## Comments and Concerns about the Construction Plans for the Serene Conservancy.

by Dr. Ed Holroyd

southeast corner

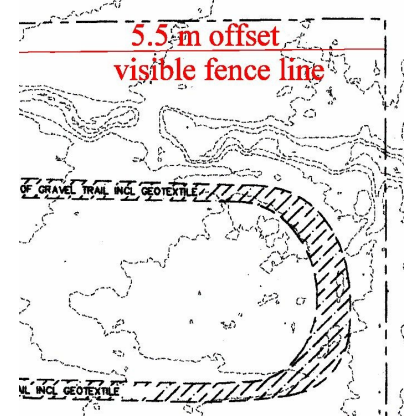
The following extracts show the comparison between the construction map property boundaries and the actual positions. The offsets are measured approximations and should be refined.

West, entrance pond and safety fence in green

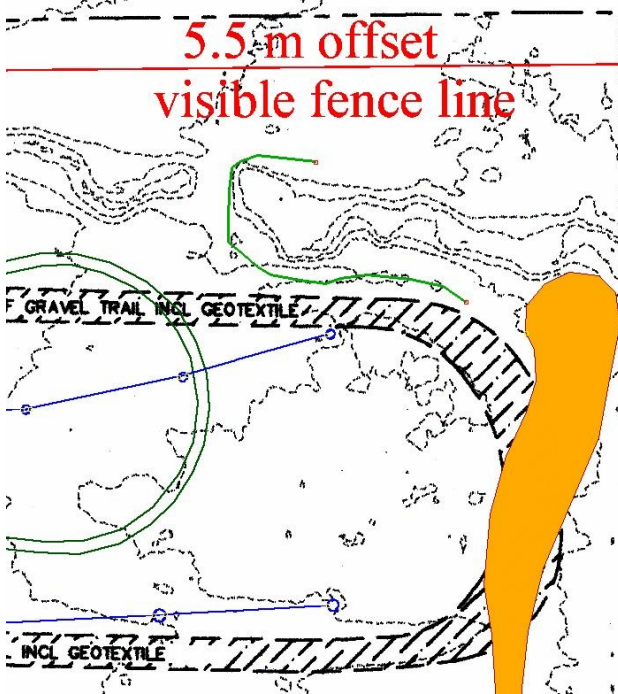
The west pond at the entrance has very steep banks which are of very slippery clay when wet. I erected this fence at the top edge of the cliff edges so that people, running kids, dogs, etc. cannot accidentally fall into the pond.

The playground is likely drawn 5.5 meters too far north and overlaps the pond edge. Correcting the playground map position eliminates the conflict with this safety fence. This fence should not be removed because of the expected nearby activities.

Northeast corner, Van Bibber Creek safety fence

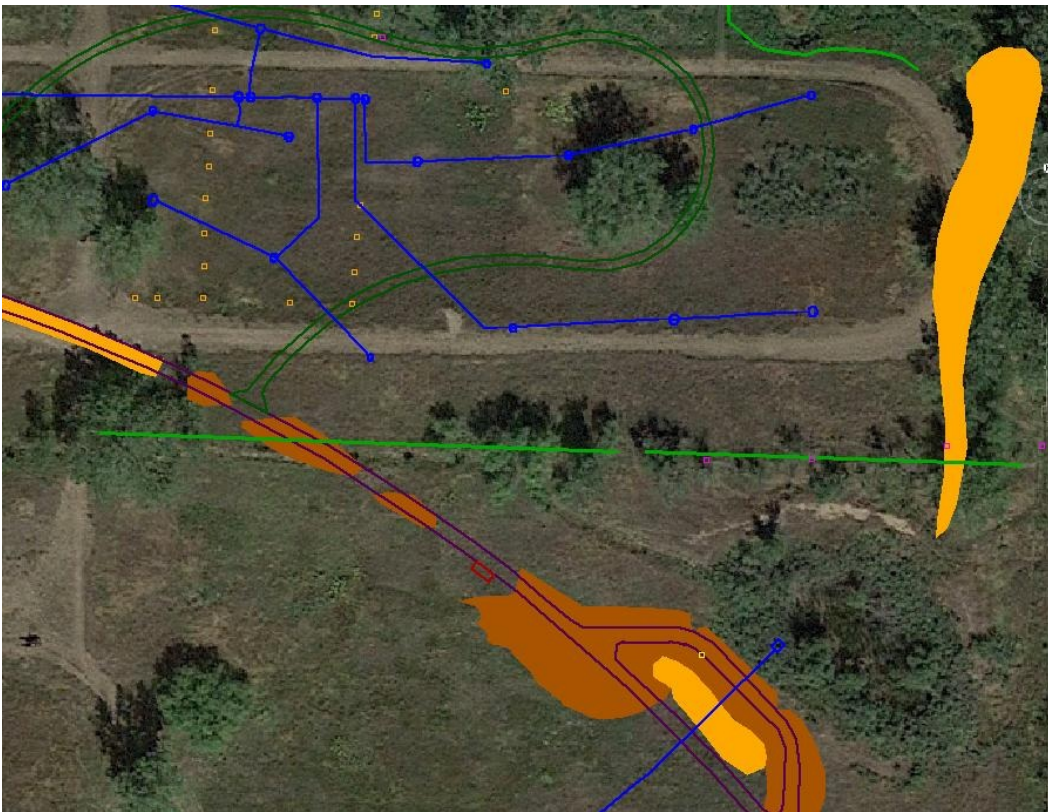
Early this year when the general public began much use of the gravel trail for walking themselves and dogs, I noticed how close they got to the collapsing banks of the Van Bibber Creek. It was an obvious safety issue. So I erected the fence indicated as the medium green line. The dark green circular green is the proposed grassy pathway of the construction proposal. The yellow area is a cut for drainage. The blue features are parts of the irrigation system. The 5.5 meter position error could be present in the Construction features.

To the west of the small culvert the creek banks are not collapsing and are adequately away from present and future pathways. So a fence does not seem to be needed there. My new fence does not interfere with future plans. It provides safety for people who wander off the designated pathway. Its open ends allow people into the safe parts of the creek edges, such as for dog watering and plant inspections, if they wish to do so. So I recommend leaving this safety fence in position as the banks continue to collapse and erode.

Middle fence, shown as straight green lines.

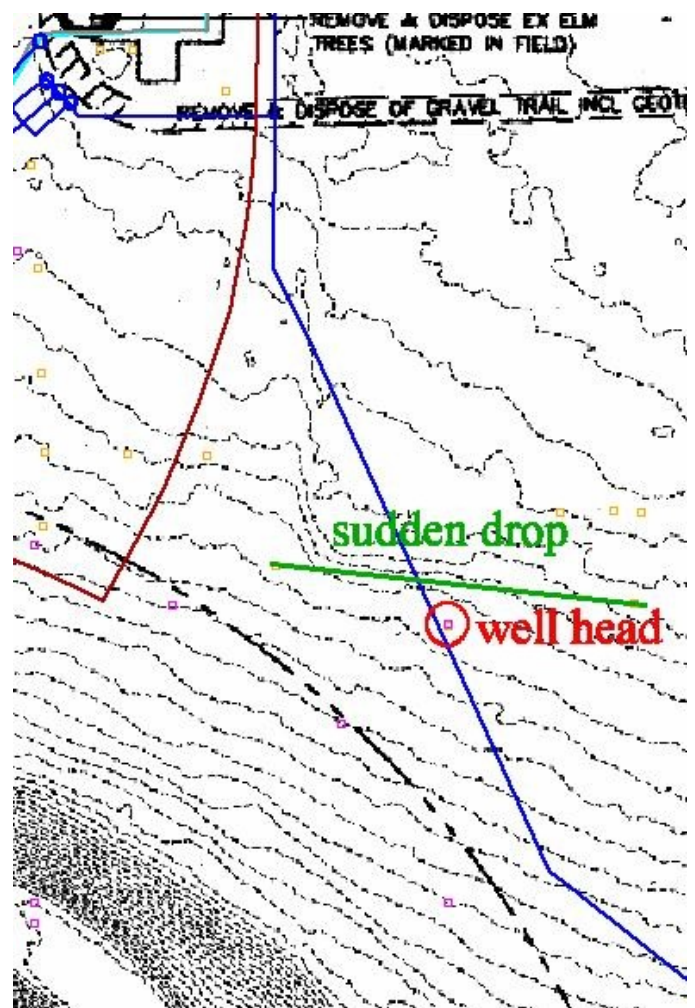
The west end of the middle fence is on the north rim of the central ditch. The east end used to continue to the property line. It is shown as a pair of straight green lines. The gap in the middle is for the passage of deer and coyotes. It was an existing fence. It does not have a major safety purpose and can be removed. The ditch can be an inconvenience to travel across the field, especially when wet in the Spring, but is obvious to a walker.

This fence needs to be cut anyway by the crusher-fine pathway (dark red parallel lines). The yellow areas are cuts and the orange areas are fills. The blue features are proposed irrigation components. The curved green parallel lines are the grassy path. The tiny orange squares are existing wooden posts, some of which may be removed. Though the crusher fine pathway appears to be properly located, some of the other construction features may have the 5.5 meter position error.

The blue line is the proposed irrigation supply pipe. To avoid the sudden drop in elevation, I suggest that the irrigation pipe be diverted around the west end of this fence on its way to the picnic area. As drawn it also crosses a hidden well head pipe (circled red square just below the green line) that I have marked in the field with a T-post.

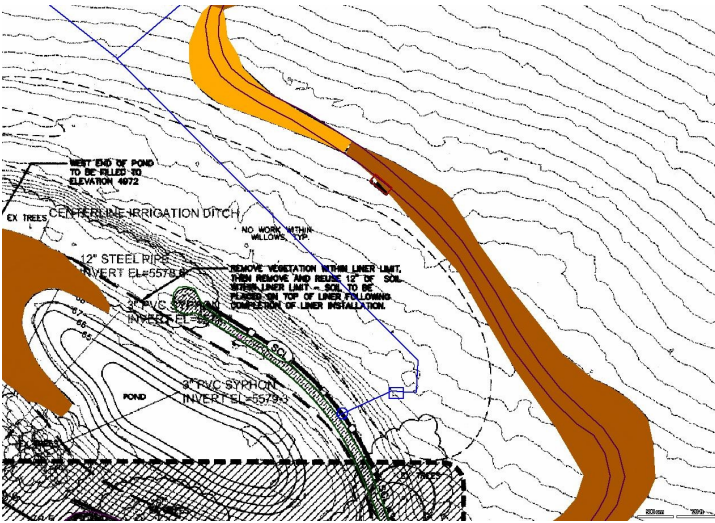
The small central message says "NO WORK WITHIN WILLOWS." The thin dashed line approximates the extent of the willows.

present it is very challenging to walk through those willows because of interlocking curved dead branches. The yellow area is a cut; the brown areas are fill. The parallel dark red lines are the crusher-fine pathway.

The blue irrigation pipe line runs in the middle of the willows. irrigation pipe location passes right through the middle of them. That will create a major construction scar.

North part of gravel trail, west end, with wells (red) and posts (yellow)

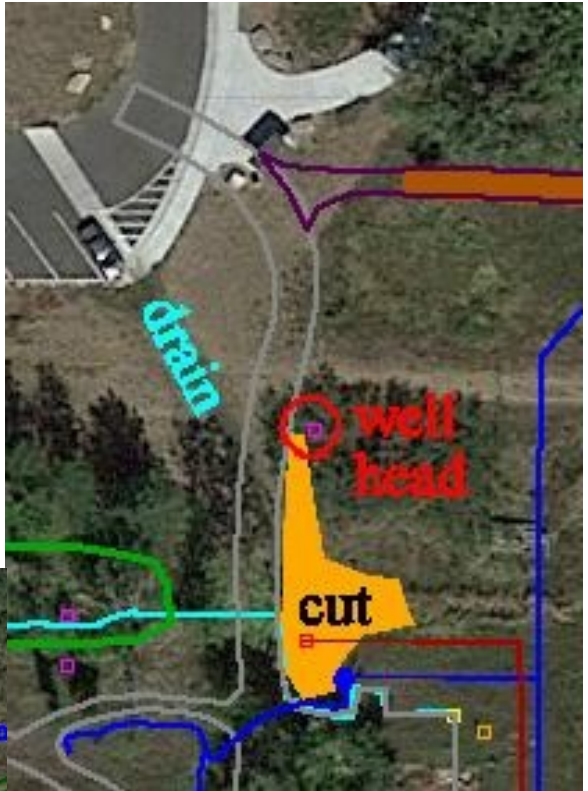
One hidden well head has already been mentioned that will interfere with construction plans. There are more.

As previously mentioned, the picnic and playground drawings appear to suffer from the 5.5 meter offset, making them farther north on the terrain than they should be. In the illustration, the gray parallel lines show the proposed concrete pathway from the parking lot to the picnic and playground areas, without correction for the position error. The diagrams do not mention a drainage pipe under the concrete path to accommodate the drainage from the parking lot. They do not mention the pipe from the entrance pond to the middle drainage ditch. They do not indicate the major well head facility hidden in the willows. Though the rest of the crusher-fine trail (maroon lines with orange fill) seems to be properly positioned with respect to the terrain, this ending near the parking lot suffers from the 5.5 meter offset of the rest of the construction features in this area.

Water-related features in the central north, adjacent to Van Bibber Creek

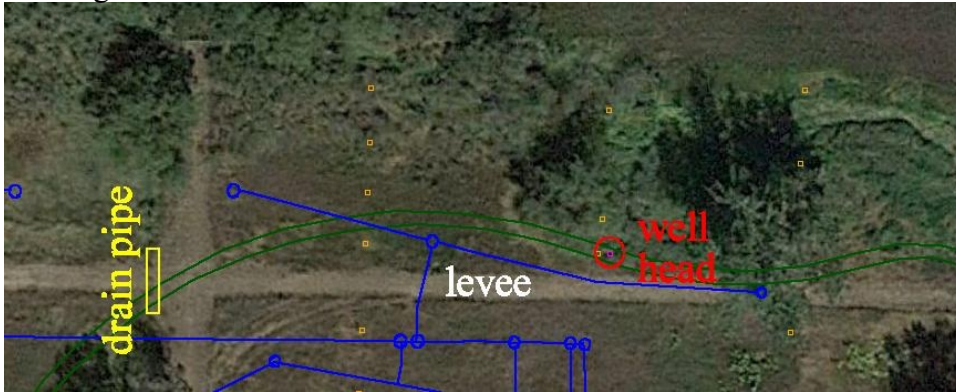
Under the large cottonwood trees north of the northern gravel trail (levee) are two large circular wells now covered with a

wooden rectangular box. As drawn, the irrigation system cuts through this well location. However, if the irrigation system suffers the typical 5.5 meter offset to the north, a corrected position will avoid interfering with that large well.

Farther east at the northern gravel trail intersection is a large pipe that lets excess water drain northward to Van Bibber Creek (at the top edge of this view). During the September 2013 flood the gravel trail functioned as an important levee, keeping most of the flood water to its north side. However, water flowed southward (backward) through the drain pipe, permitting a flooding within the eastern loop of

the gravel trail. If not for the southern part of this loop also functioning as a levee, the flood water would have reached the drainage ditch that leads to the eastern pond. (See later drawing) The construction plans show no knowledge of this important drain pipe, nor the importance of the gravel trail as a levee.

There is another hidden well head, shown in the image as the circled red small square. As drawn, the proposed grassy trail passes over it and parts of the proposed irrigation system are nearby. At that location the grassy trail passes too close to Van Bibber Creek and under low-hanging tree branches. If the construction drawing of these features suffers from the 5.5 meter position error, a corrected position about 18 feet to the south would avoid the conflicts.

Playground area

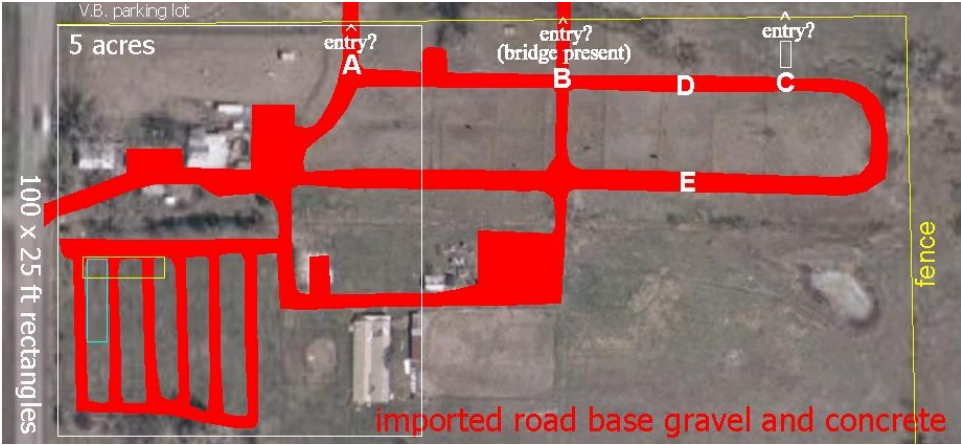
The construction plans as drawn for the playground likely have it positioned about 5.5 meters (18 feet) too far north of the actual field locations. Rather than circling the large existing tree, a concrete pathway cuts through its location.

Along the axes of the troughs between the gravel ridges are pits shown by the magenta circles (with only crude GPS accuracy). The pits likely contain large stones, the remains of plastic plant buckets, and possible black cloth. These appear to be functioning as drains. If so, there may be hidden drainage pipes running N-S

between them, following the alignment of the troughs. In the upper right of this view there are pipes of different sizes that serve a drainage function. The construction plans do not notice the large drainage pipe, nor the large pipe (not shown here either) under the driveway that connects the entrance pond to the central drainage ditch. During construction the drainage of the playground area needs to be properly addressed. (There are more pits to the west of the illustrated area that will not be interfering with construction plans.)

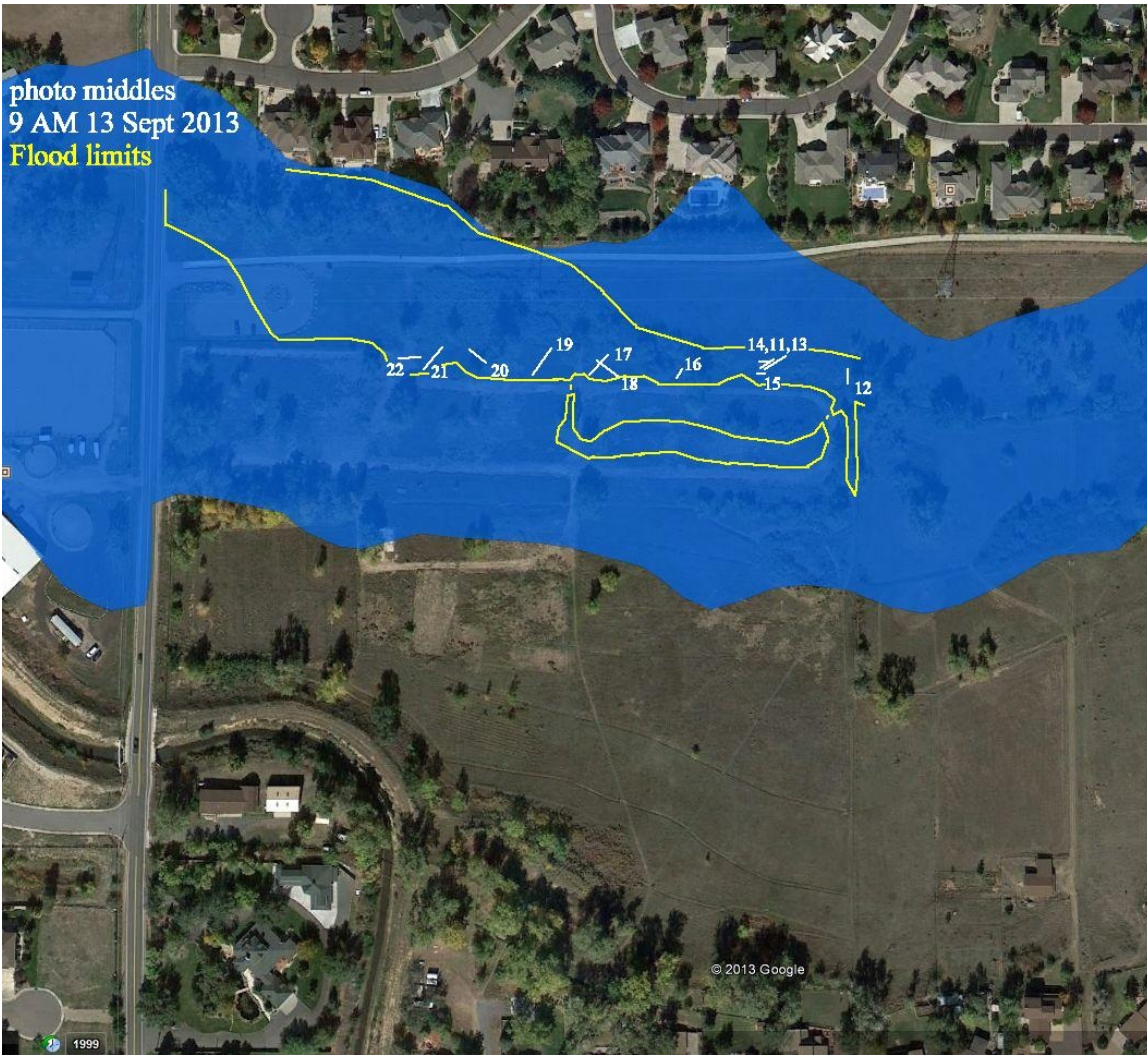
sand. They are wider than drawn. This illustration, previously drawn in 2007, shows in red all areas of imported gravel and concrete on an older aerial photo that shows the former farm buildings. Note that the southern loop has a huge area of gravel previously used for parking and not noted in the construction plans.

As previously communicated, the gravel trails with labels A,B,C,D,E functioned as levees during the 13 September 2013 flood. The official 100-year flood plain shown in blue in a next image is much wider than the area flooded in 2013, indicating that floods of the 2013 magnitude are much more frequent than 100 years.
